Subject: Duke Energy Carolinas, LLC (Duke Energy)
McGuire Nuclear Station, Units 1 and 2
Docket Nos. 50-369 and 50-370
Relief Request Serial # 11-MN-001, Response to Request for Additional
Information on Limited Weld Examinations for Refueling Outages 1EOC20 and
2EOC19

McGuire Nuclear Station Unit 1 and 2

Relief Request 11-MN-001 Request for Additional information (RAI)

1EOC-20 and 2EOC-19 Limited Weld Exam Third interval 10 Year ISI

McGuire Flow Diagram MCFD-1554-01.02 rev 11 with weld location identified for Section 4 weld #1NV1FW53-27:

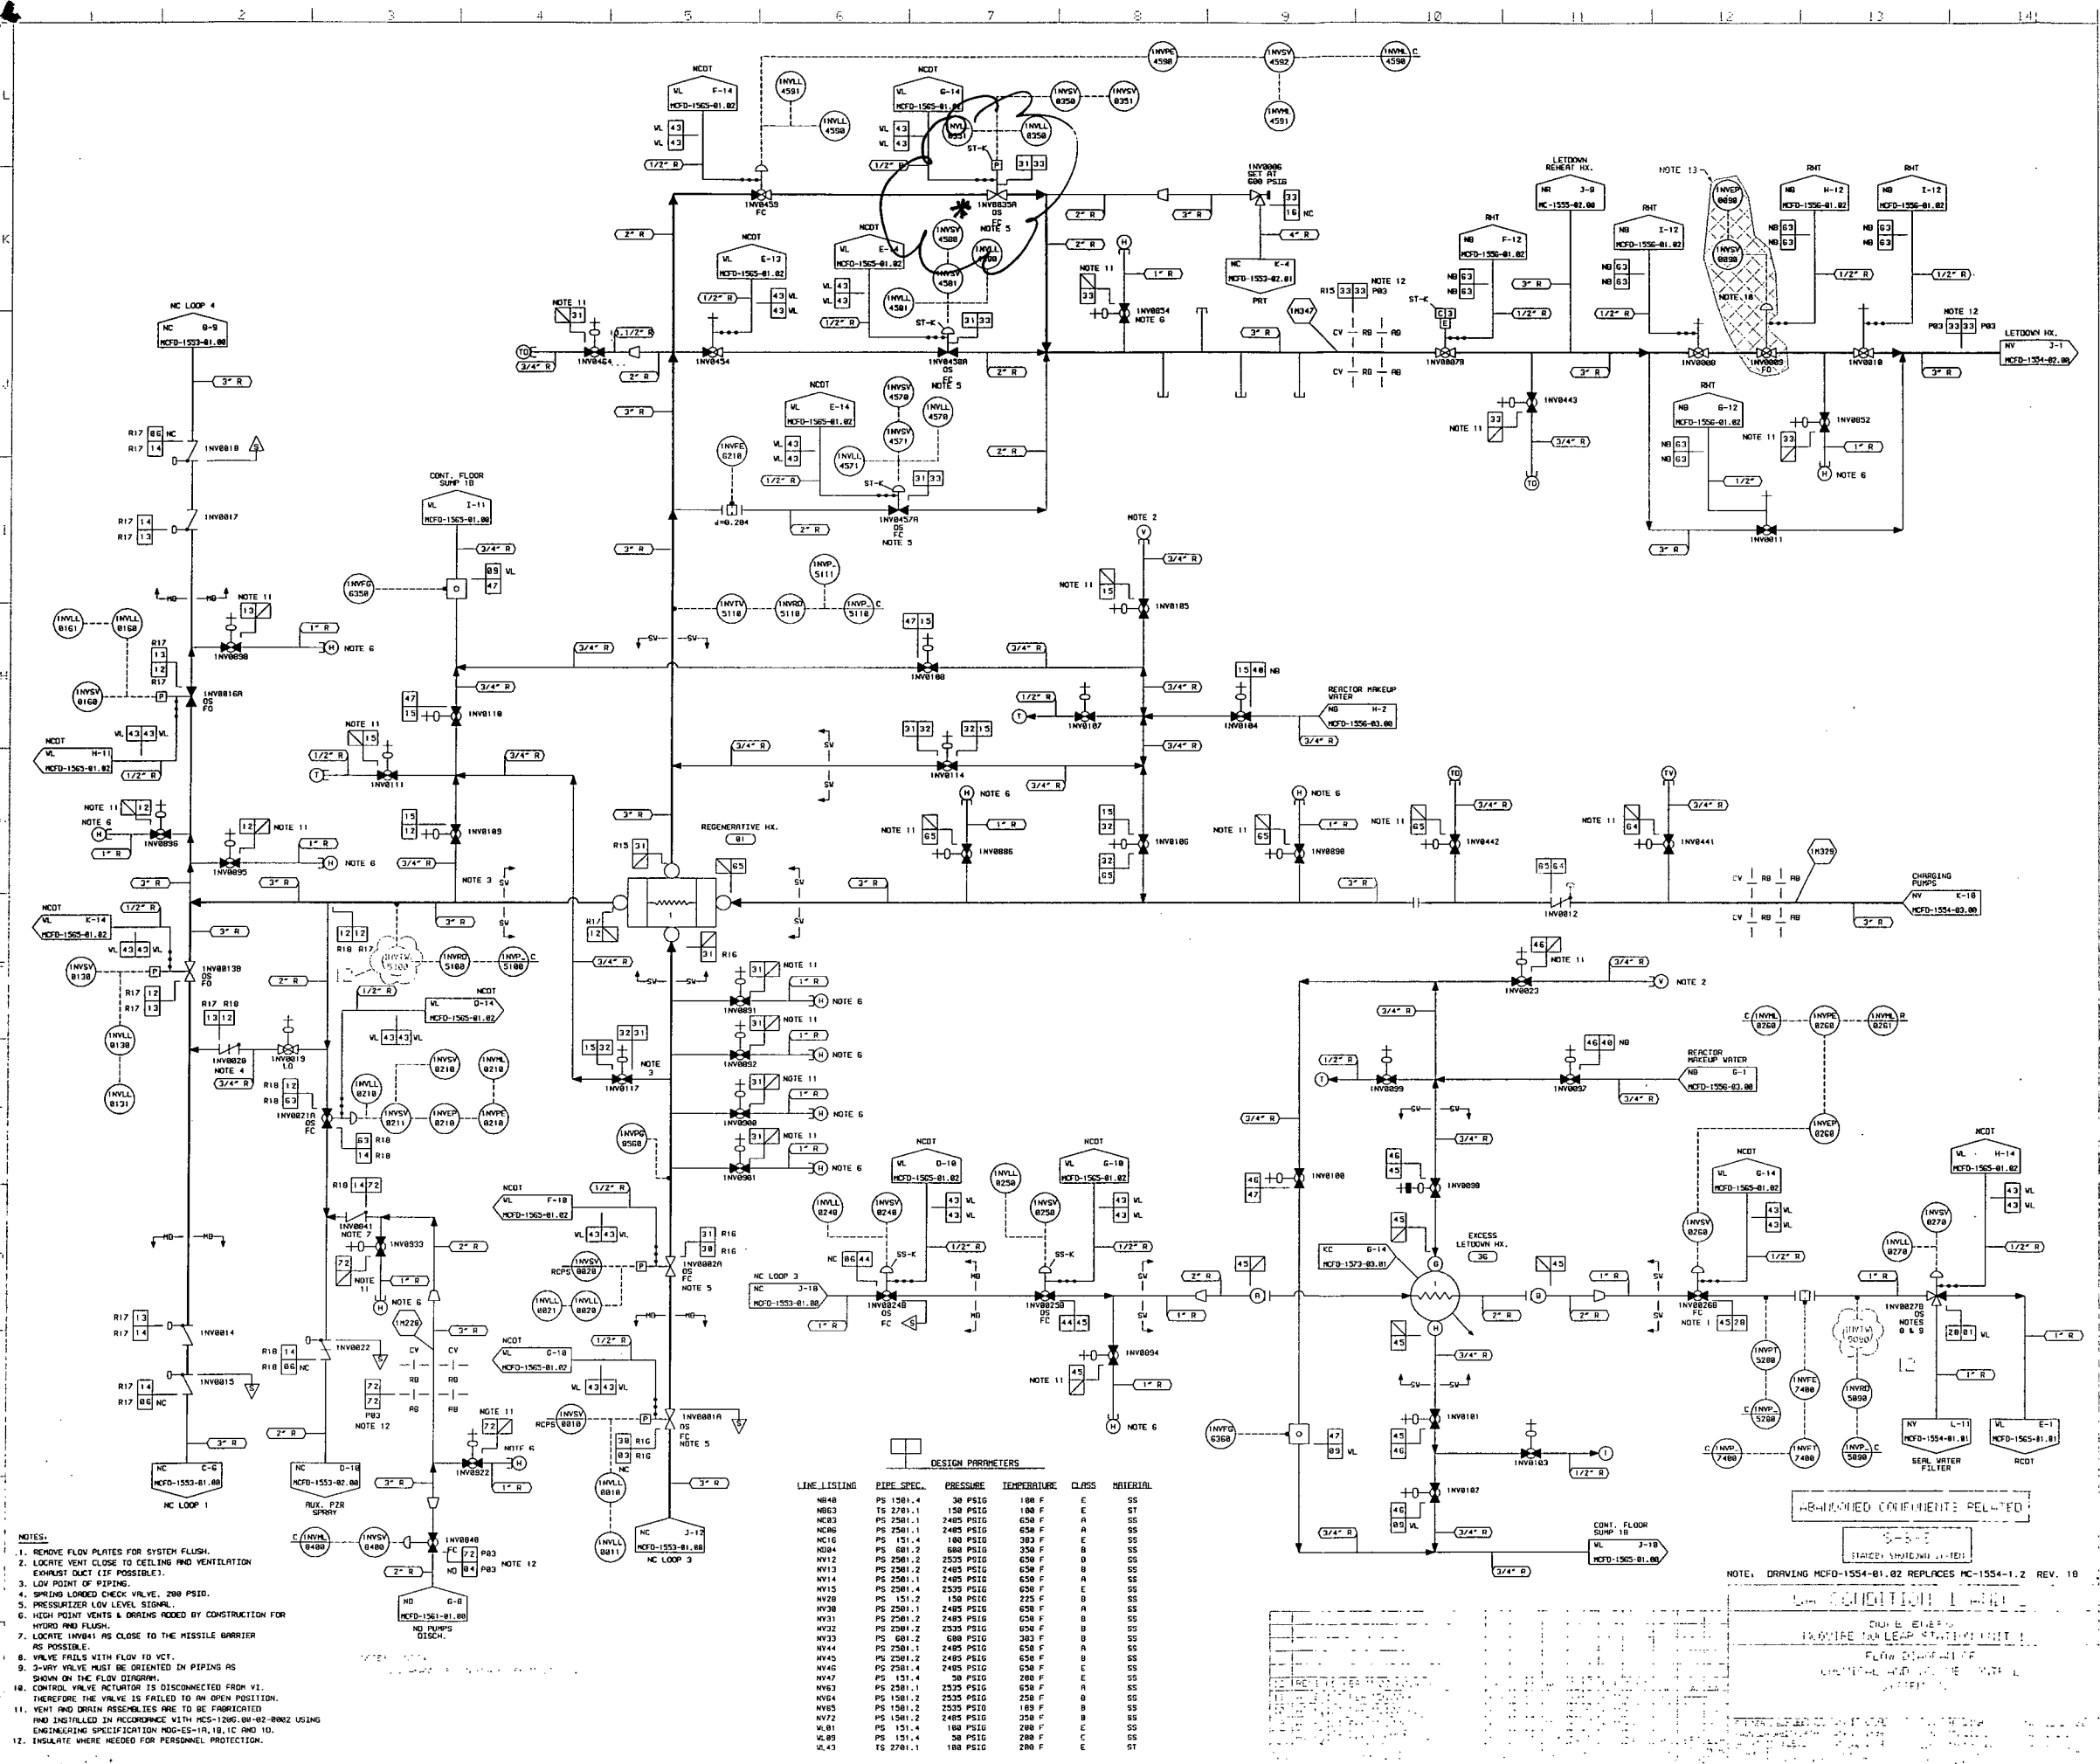
For sections 2, 4, 10, 11, 12, 13, 14, 15, 16, and 17 the components are described as being made of stainless steel. For each weld, please specify which components, if any, are made of cast stainless steel.

Duke Energy Response: The one weld associated with these sections that connects to a component fabricated from cast stainless steel is listed in Section #4 (weld #1NV1FW53-27). The specific component fabricated from cast stainless steel material (ASME SA 351 Grade CF8M) is valve 1NV-35A.
